SERVICE BULLETIN

TS-830S

#857

SUBJECT: TS-830S Transmitter "Talkback"

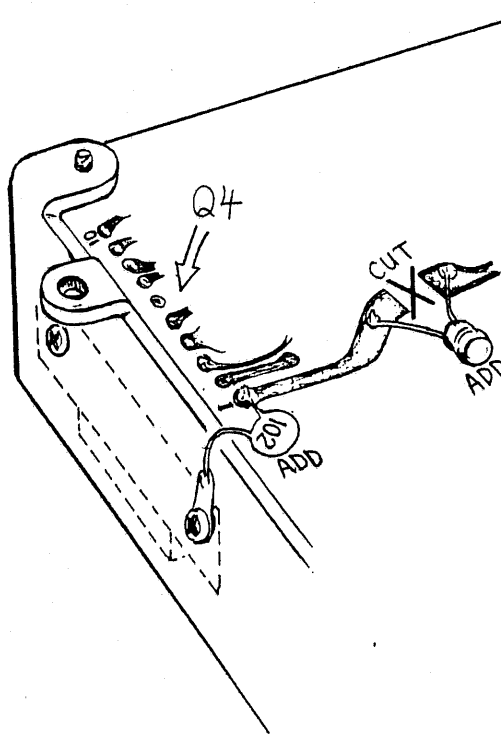
Transmitter "talkback", either with or without a linear amplifier, may be eliminated by adding a filter at the receiver audio power amplifier.

On the AF unit X49-1140-00 at Q4, cut the 12V DC B+ line between R47 and C28, and add a 1 μ h choke (L40-1092-02) in-line. Add a .01 μ F cap (C52-1710-36) from the IC pin 1 to ground, as shown using a 3mm lug (E23-0015-04) under the IC mounting screw on the Heat Sink.
